TOWN OF MILTON DEVELOPMENT REVIEW BOARD

STAFF REPORT

Hearing Date: July 9, 2015	
Case No: 2015-20	
Application(s)/Requested Action: Site Plan	
Existing Use: None	
Proposed Use: Truck Stop	
Application Received: June 8, 2015	
Application Deemed Complete: June 10, 2015	
Staff Report Finalized: July 3, 2015	
Applicant(s): T. Chase Investments LLC c/o Neagley & Chase Construction Co. 66 Bowdoin Street, Suite 100, S. Burlington, VT 05403 TChase@neagleychase.com 802.658.6320	Owner(s): Same
Engineer/License: Andrew Rowe, P.E. Lamoureux & Dickinson Consulting Engineers, Inc. 14 Morse Dr., Essex VT 05452 802.878.4450	Surveyor/License: None
E-911/Postal Address: None, Catamount Drive (Lot 14 B of the Catamount Industrial Park)	
Tax Map, Parcel(s): 3, 8-145	
School Parcel Account Number(s) (SPAN): 11527	
Deed(s): Book 359, 130	
Existing Size: 3.34 acres	
Zoning District(s): "General Industrial "I2"	
Comprehensive Plan Planning Area: Catamount	
Location: Corner Lot at corner of Catamount & Industrial Drive

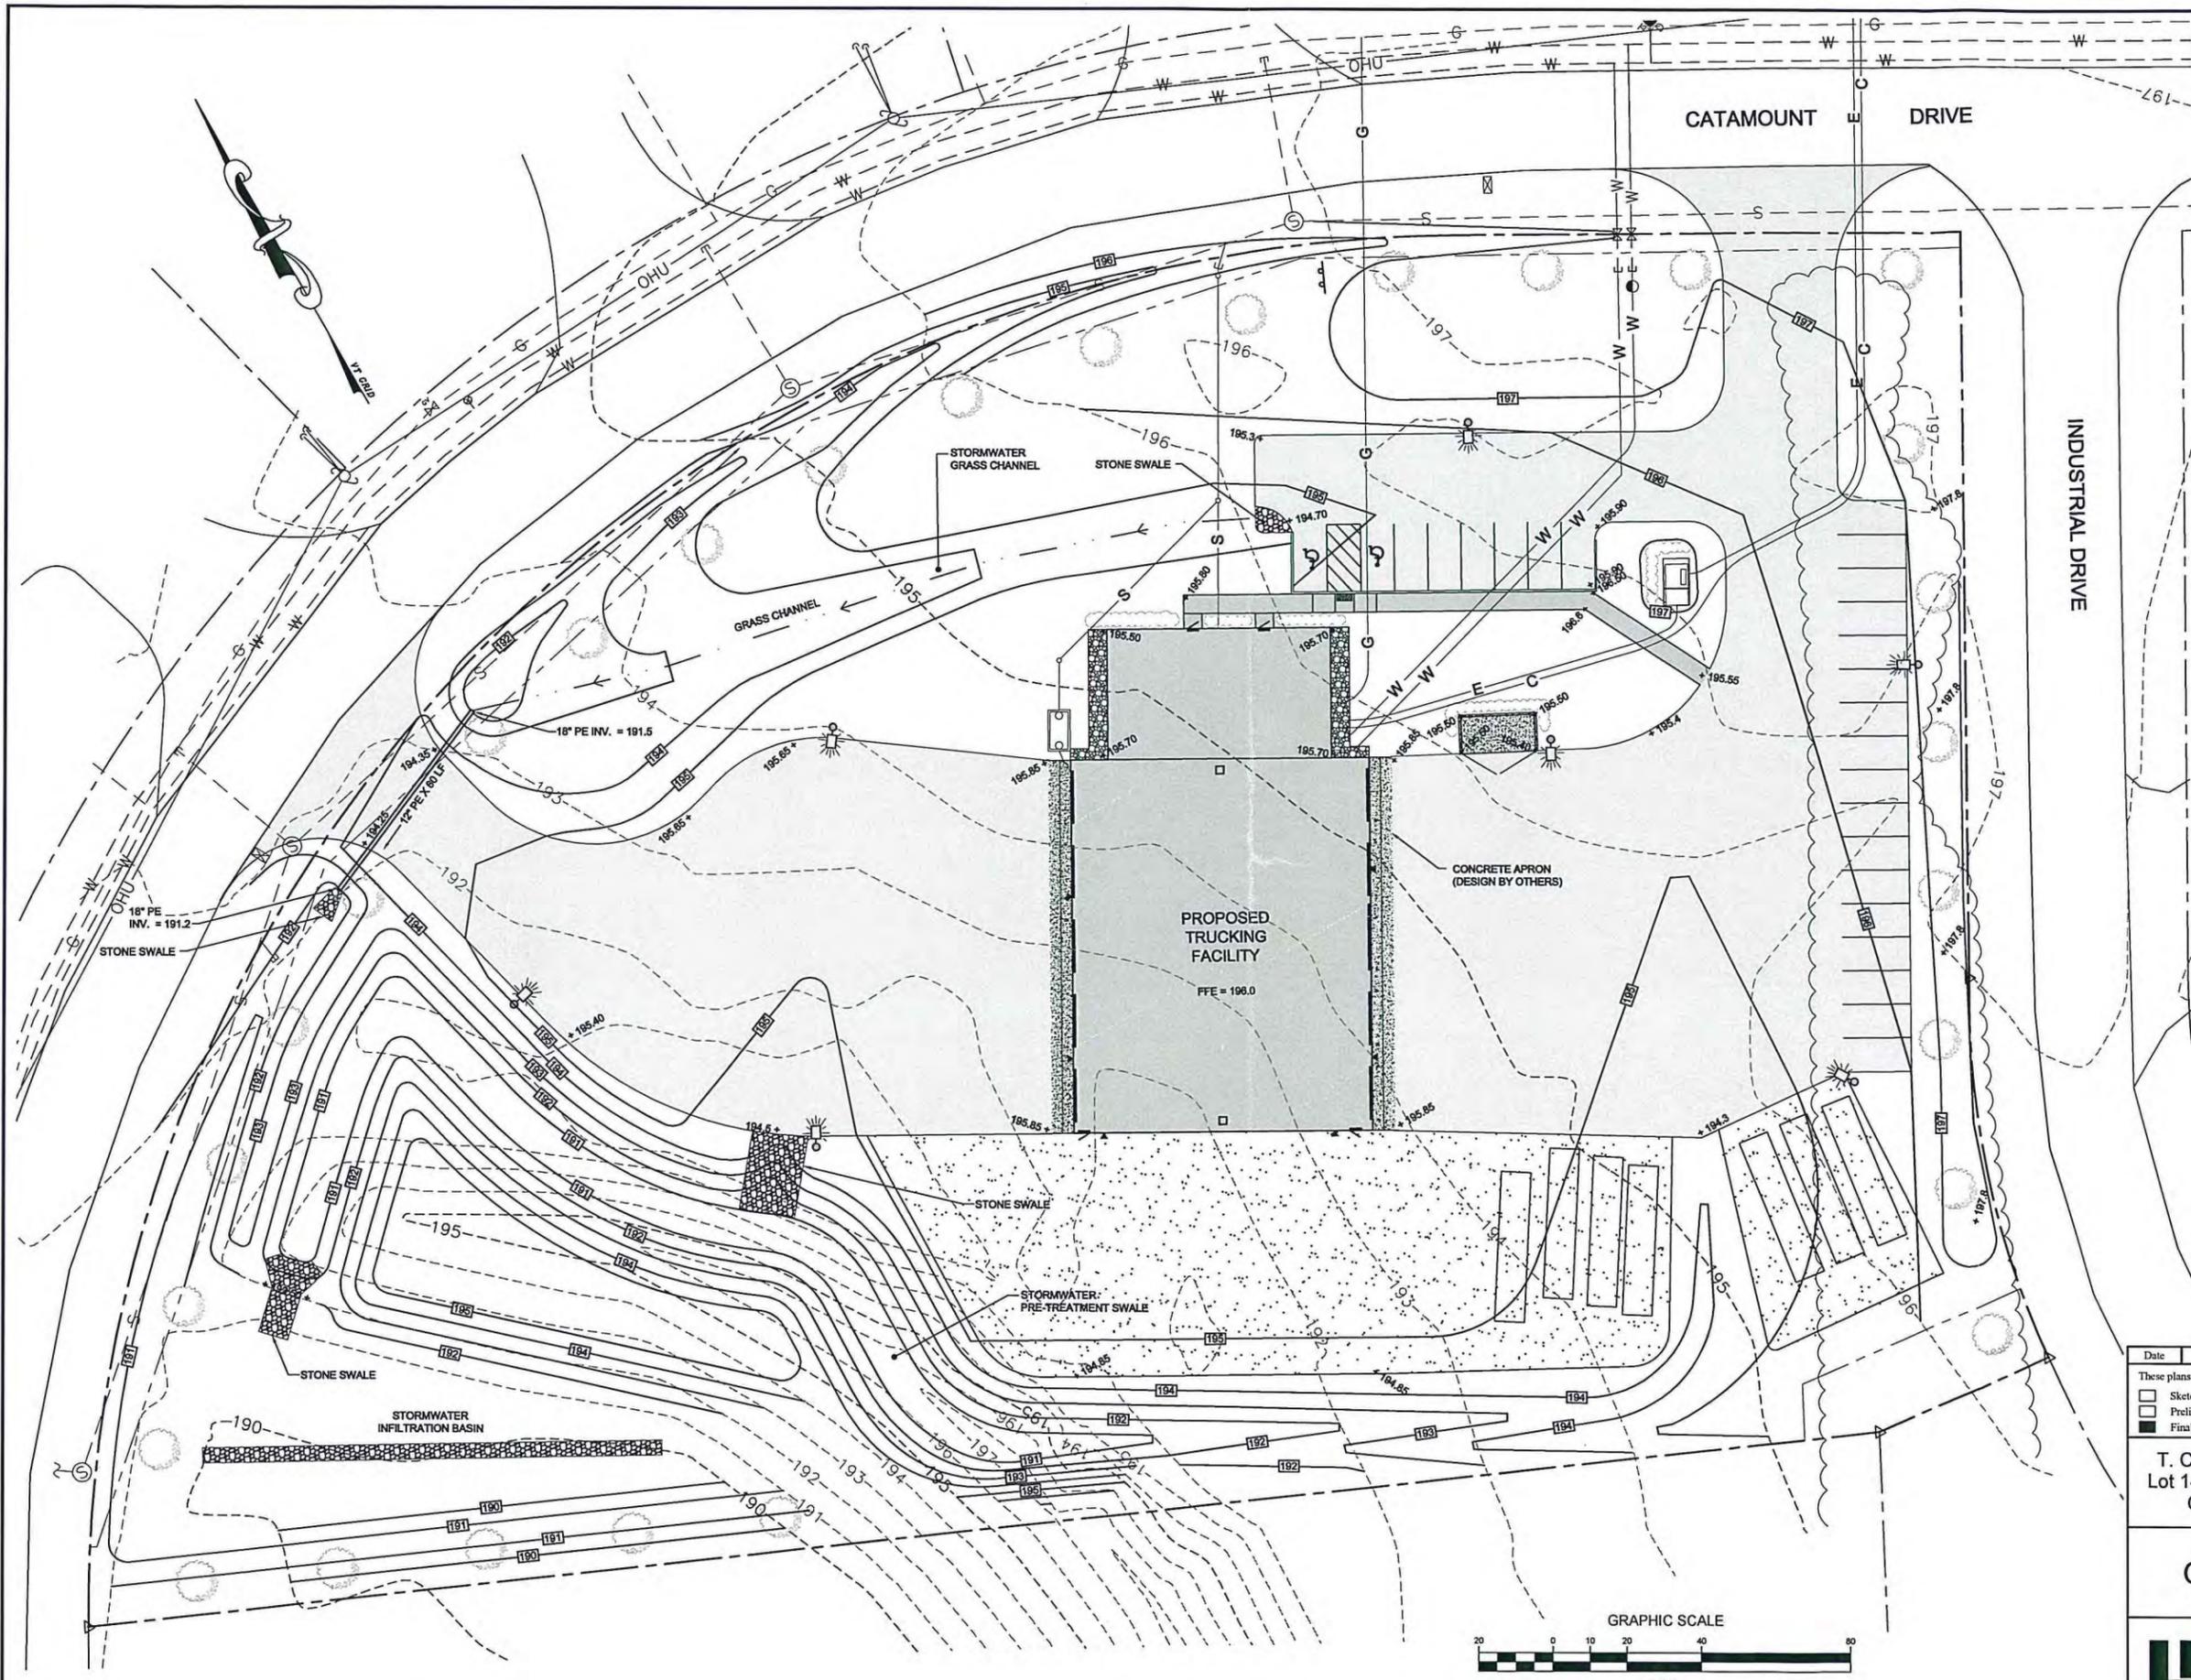
7. The Final Plans shall revise the landscaping plan (and associated cost estimates) to minimize the visual impact of the outdoor trailer parking area on a year-round basis.

10. The Final Plans shall show parking barriers between front parking lot spaces abutting the front sidewalk.

ZR819, Bicycle Parking Space: The plans do not show a bike rack. A bike rack is required.

TYPICAL WATER TRENCH DETAIL
NTS

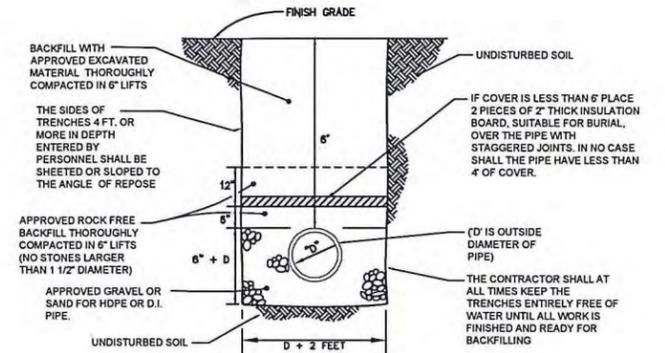
- Water Trench – The detail shall be corrected to comply with Public Works Specifications Drawing #18. Specifically, all water and fire services SHALL be insulated where they are buried beneath paved or traveled areas regardless of depth.
- Missing water connection details, curbstop, gate valves, etc.
- Provide a water & fire service entrance detail to include the water meter and backflow prevention.

T. CHASE INVESTMENTS, LLC Lot 14B Catamount Industrial Park	Date 6-8-15
	Scale As Shown
LIGHTING PLAN	Sheet number 6

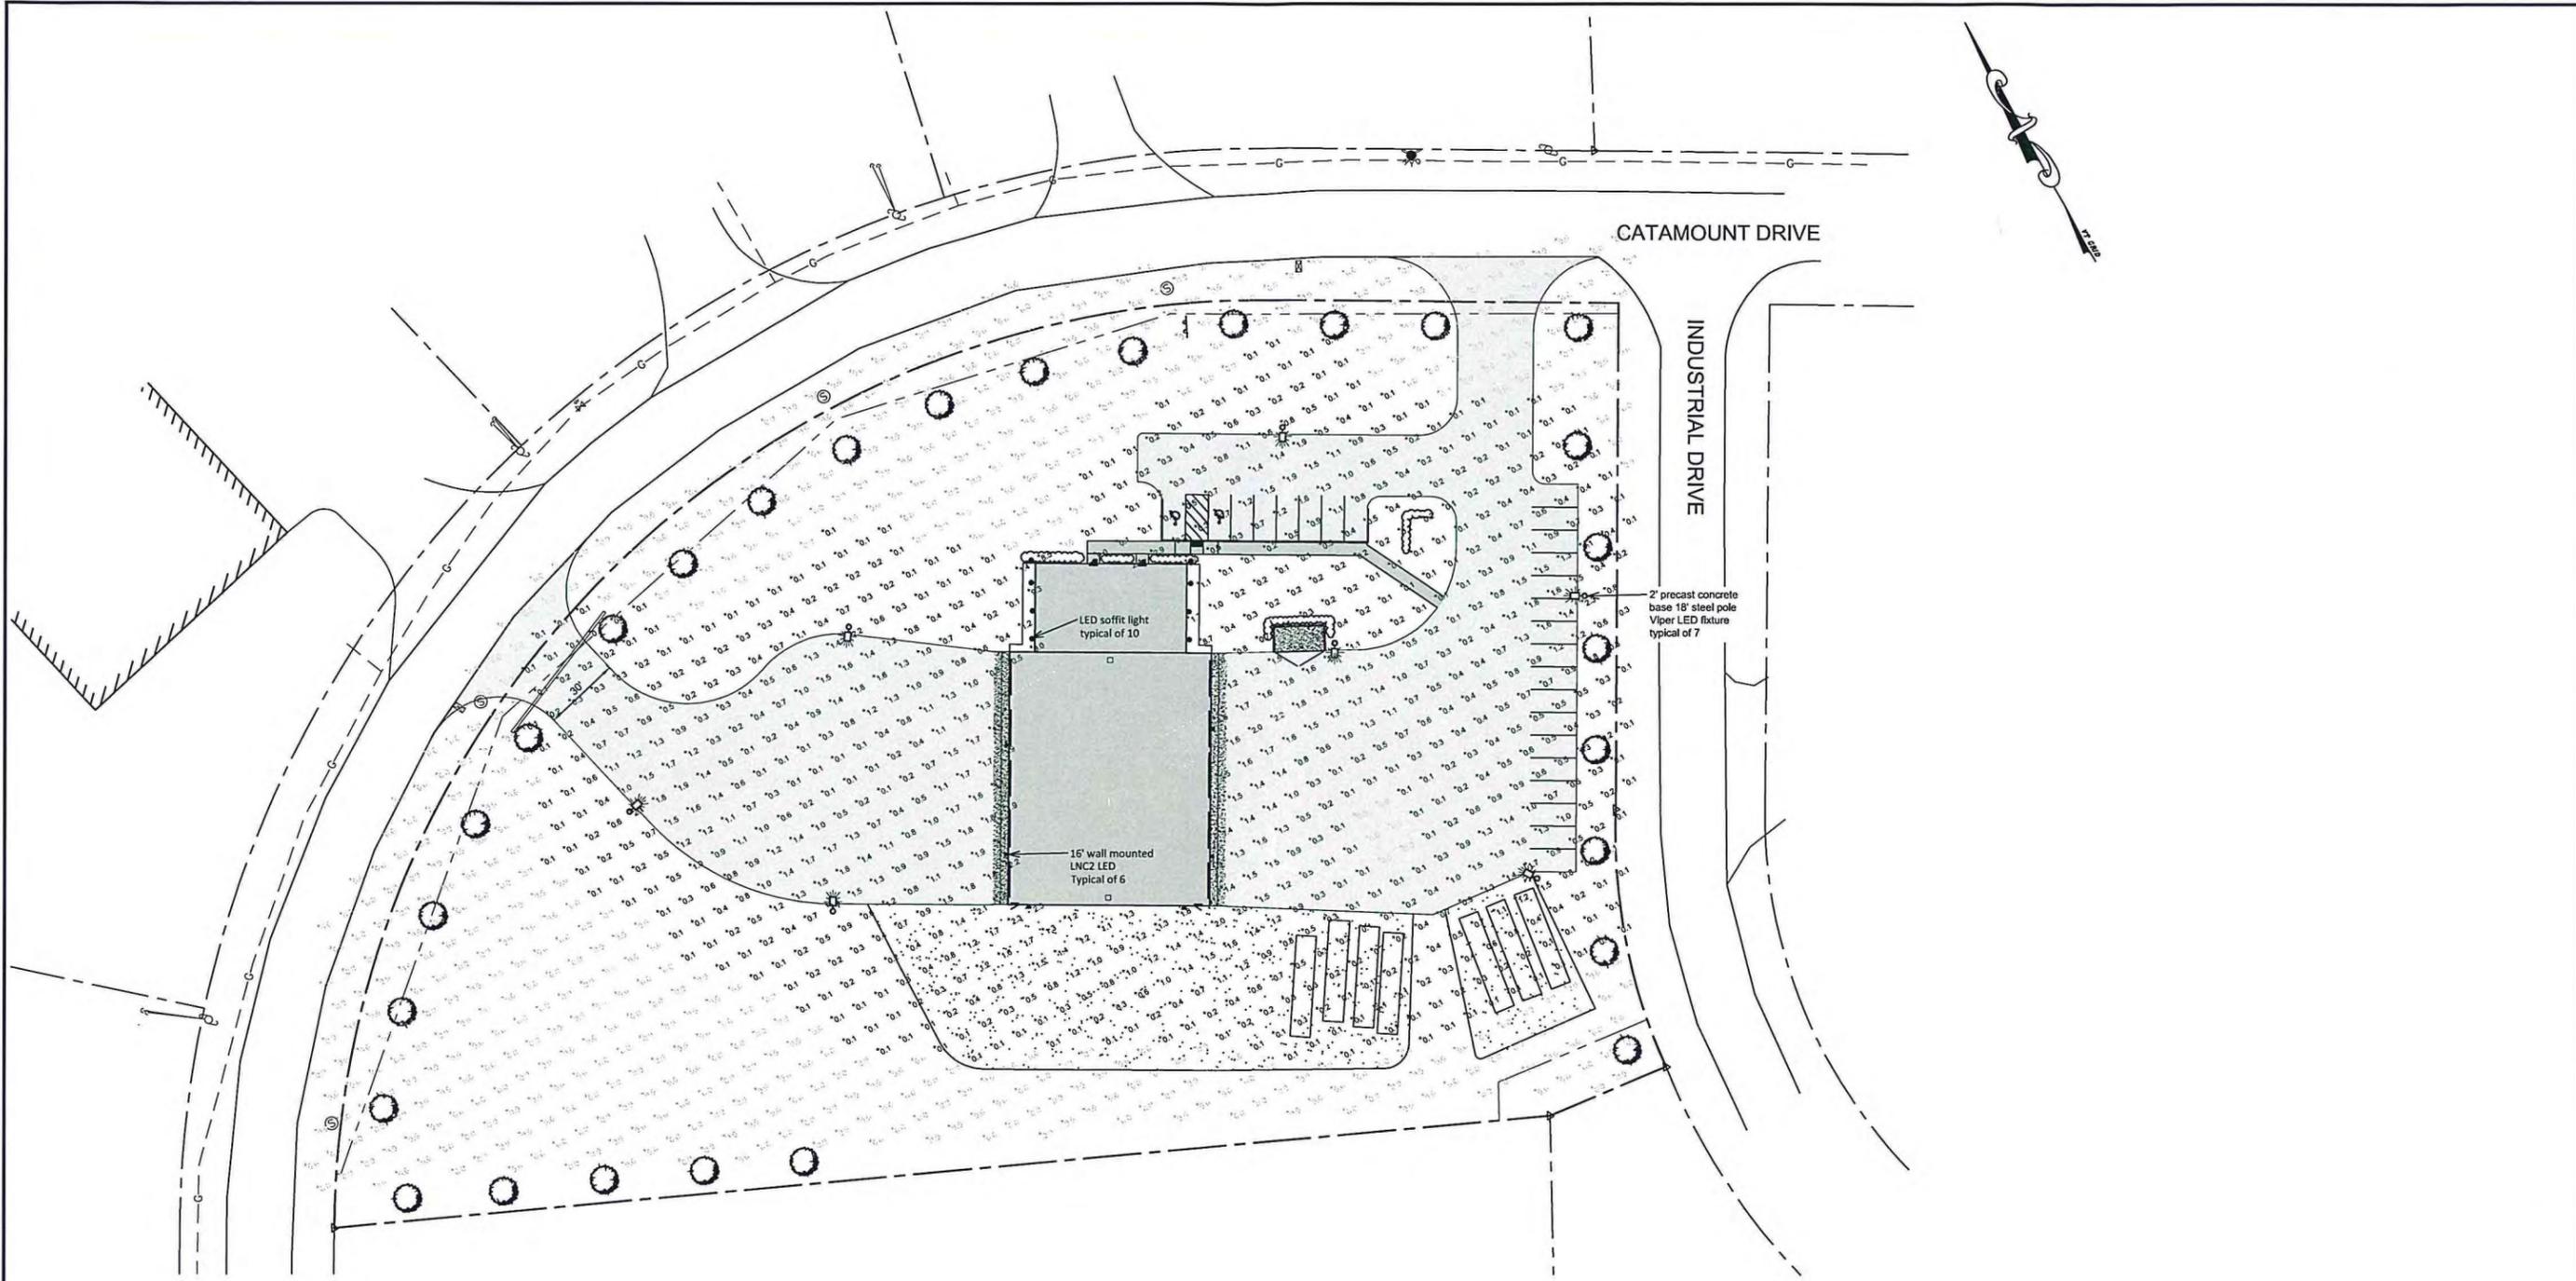
13. The Final Plans shall include lighting specifications demonstrating compliance with ZR820.
